Agenda Report

TO: Honorable Mayor and City Council
FROM: Planning & Community Development Department
SUBJECT: PREDEVELOPMENT PLAN REVIEW OF A MIXED-USE DEVELOPMENT AT 141 SOUTH LAKE AVENUE

Figure 3: Ground Floor Plan

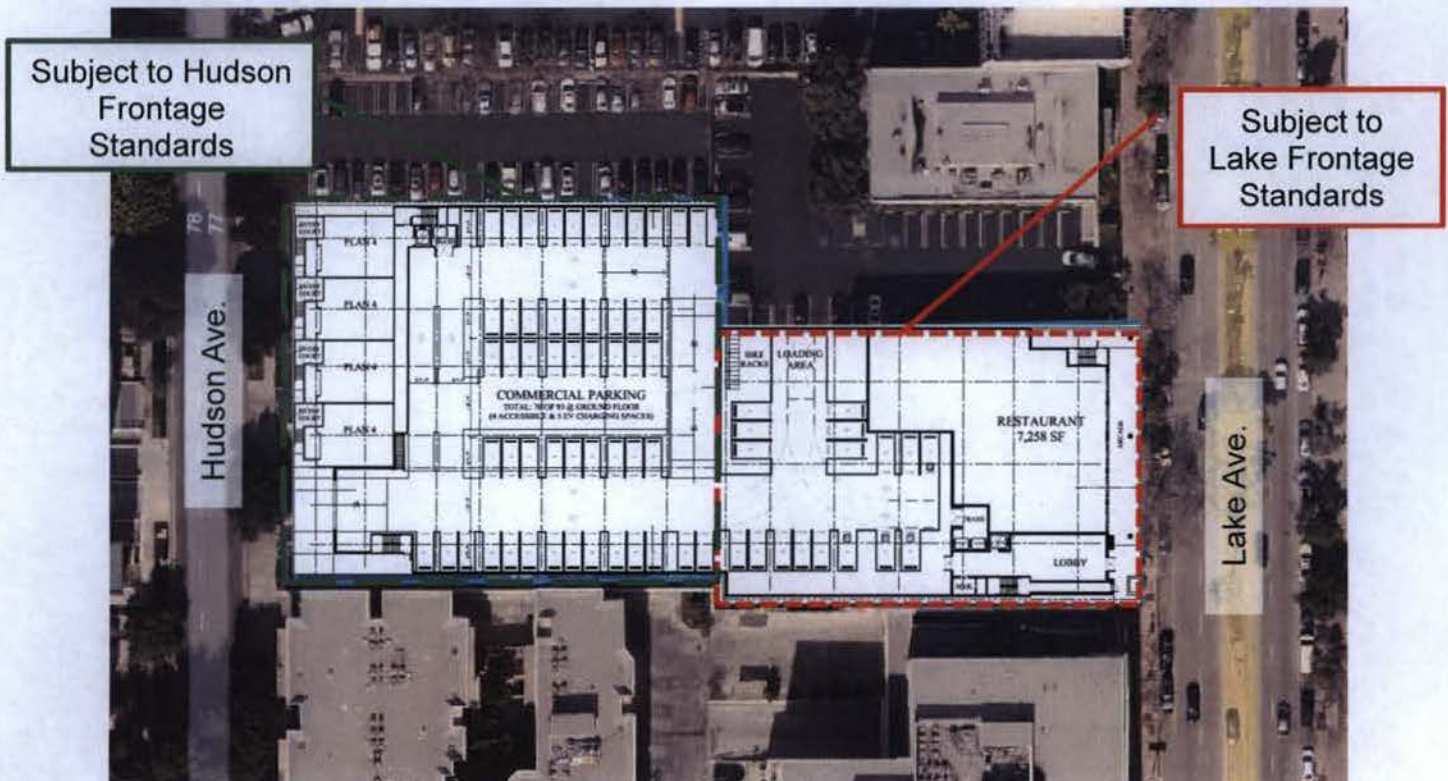
- Significant and pedestrian friendly entries and lobbies on both the Lake Avenue and Hudson Avenue elevations should be included in the overall design. There is no residential entrance or lobby on the west elevation facing Hudson Avenue, and one should be provided. Main building entrances should be prominent in terms of size,

- Provide more detailed information about bicycle, pedestrian and vehicular circulation to and from as well as within the site and clarify how residents will access the building from both Hudson Avenue and Lake Avenue as well as access and engage with the split-level courtyard. Clarify how the different commercial users will access the commercial spaces from the parking areas. Clarify if there will be any short term vs. long term bicycle parking. The internal circulation and ground floor relationships, including a lack of pedestrian access to Hudson Avenue, is currently misguided.

- Further study the design and location of the access to the parking garage off of South Hudson Avenue to ensure it is well integrated into the project design and will avoid the appearance of a large open tunnel from the street. Further study the scale of the parking entrance to determine if it can better relate to the scale of other openings along the street, including the large parking entrance directly to the south of the property.

- Further study the grade difference between the sidewalk and the unit entryways along South Hudson Avenue to ensure an appropriate and gradual transition. Sunken entryways are strongly discouraged. The combination of above and below street access is not desirable. Above grade access is preferable to sunken entries.

Figure 4: Elevations

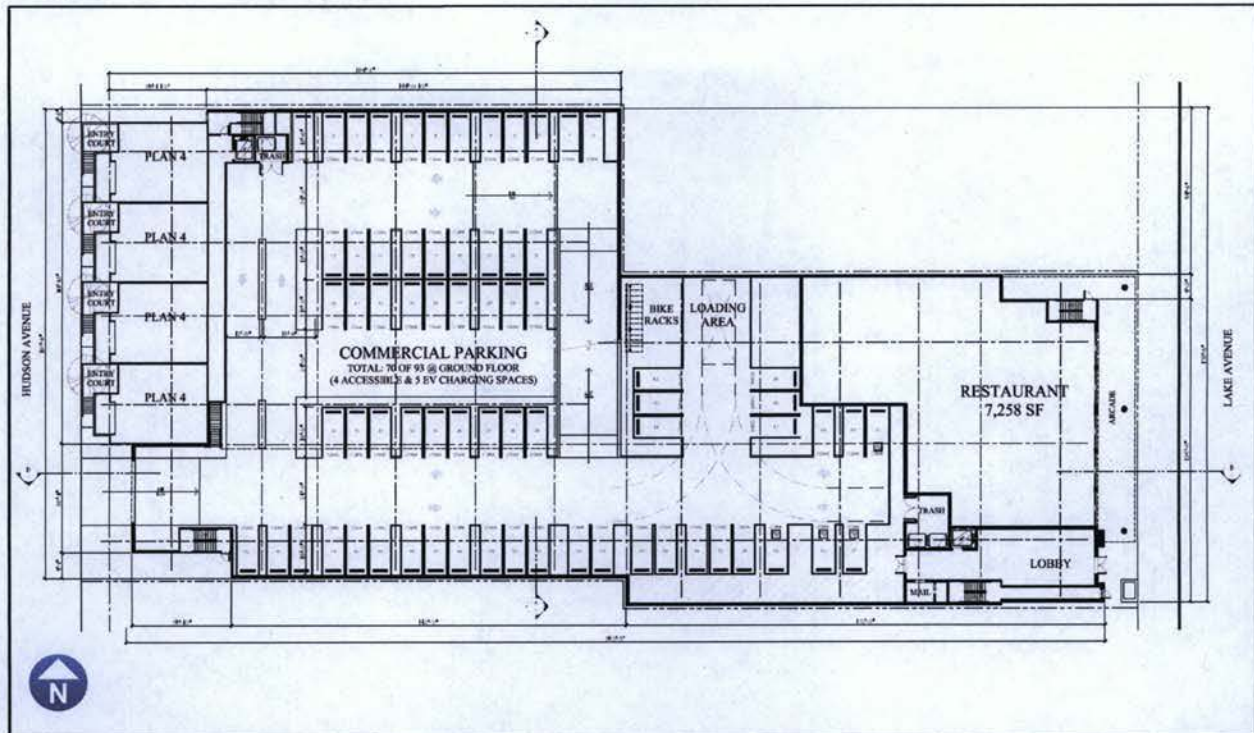
- Consider further differentiating, or more clearly explaining how the architectural character of the residential portion of the project is distinguished from the commercial portions, particularly as viewed from South Lake Avenue and refine the treatment of style and materials for each use. The ground floor commercial uses should be visually distinct from the residential space above; residential entrances should read differently from entrances to ground floor commercial uses. The residential portions should have more consistency in design, currently there appear to be too many competing patterns. It would also be appropriate to treat the Hudson facing elevation differently, as it is distinct from Lake Avenue and not visually connected.

- The lightly supported mass of the second story office space and the balcony above appears to inappropriately dominate the primary elevation rather than enhance or compliment other significant building features. Explore ways to better integrate this feature into the overall design concept of the building. The use of recessed windows that create shadow lines and suggest solidity is strongly encouraged. Reconsider what users will have access to the large balcony above the second story projected mass of the office space. The current scheme of limiting it for the private use of only a few units is not appropriate, as this significant and prominent open space and should be programmed for common use. In addition, the visual transition between this space, the balcony of Plan 4A, and the residential lobby volume should also be further studied to ensure a more harmonious transition in materials and function.

- Study ways to better engage the outdoor dining and the projecting mass of the second floor office space on the east elevation with the rest of the building design and further explain how the outdoor dining relates to the adjacent properties and the street continuity in the immediate context. The outdoor dining component should incorporate additional features to make the space more human scaled and inviting as it does not appear to be fully integrated with the overall architectural design of the building and the large unadorned support columns should relate better to the upper portions of the building. In general, the elements of verticality on the east elevation need further refinement and the solid-to-void proportions of the larger articulated tower element at the northeast corner of the building appears to be imbalanced.

- Further resolve the architectural detailing on all elevations and ensure the same level of quality and detailing is reflected on all visible portions of the building. When there is vertical circulation inside the building, this should be expressed on the exterior elevations. There also appear to be too many unnecessary two-story framed elements that do not reflect the function and programming of interior spaces.

- The design of the north elevation is unresolved and should be further studied and refined to include a full array of architectural features and detailing that appropriately responds to the adjacent eligible historic resource. Further study the composition of significant architectural elements of the primary elevation facing South Lake Avenue, such as the entryway, ground floor restaurant storefront, fenestration and mullion patterns, covered dining patio, cantilevered second floor office space, large glass balcony, and the tower like feature at the northeast corner of the building and, further refine the arrangement of these elements in a more harmonious composition with a clearly established hierarchy of significance with a base, middle and top. The use of exterior cladding materials should also follow a clearly established and logical hierarchy of significance. In addition, the predominant use of stucco is problematic; the material choices should be of a higher quality.

- The provided elevations should show the actual elevations of adjacent building, not just shadows in order to provide additional context and allow the Design Commission to better understand how the proposed building relates to the surrounding environment.
